Subject: Out Of Band Emissions @ 5.25 GHz

> FCC ID: **RVW2330B** IC ID: 332R-2330B Model: 2330B

IEEE802.11 ABG access point radio

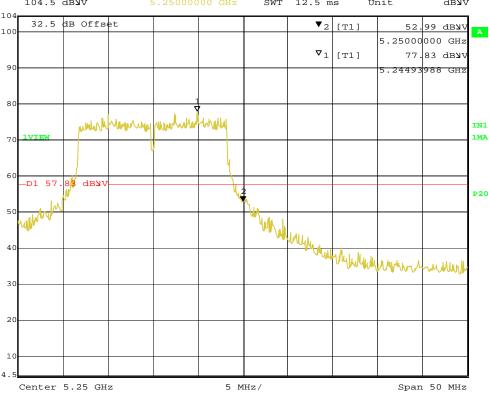
This permissive change application disables operation of the product within the 5.25 - 5.35 GHz UNII band. The unit will still be operated within the 5.15 - 5.25 GHz band. Therefore it is necessary, per FCC guidance to verify that the emissions are at least -20dBc at the band edge, 5.25 GHz when operating on 5.24 GHz.

Please see plot below which illustrates a level of -24.84dBc at the 5.25 GHz band edge.
